Access Compliance Report

Public Rights-of-Way

(Pedestrian Signals)

Intersection ID: N/A	Main Street:	Cross Street: N/A	Location: N/A
ADA ID: 39D142929778	Signal Type: One Push Button-APS	Overall Compliance: No	Severity Score: BTN 1: N/A BTN 2: N/A No BTN: N/A
Codes/Mitigation Info/Possible Solution		Field Measurements/Component Compliance

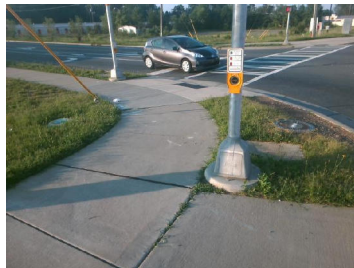
Surveyor Notes: TEXT HT 5/16

PROW/ADA: R410.6, R209.1, TMUTCD 4e.08, R404.2, R404.3, R406.2, MUTCD 4e.10

Possible Solutions: Replace Signal Push Button With APS Button on New Post. Remove & Replace Sign.
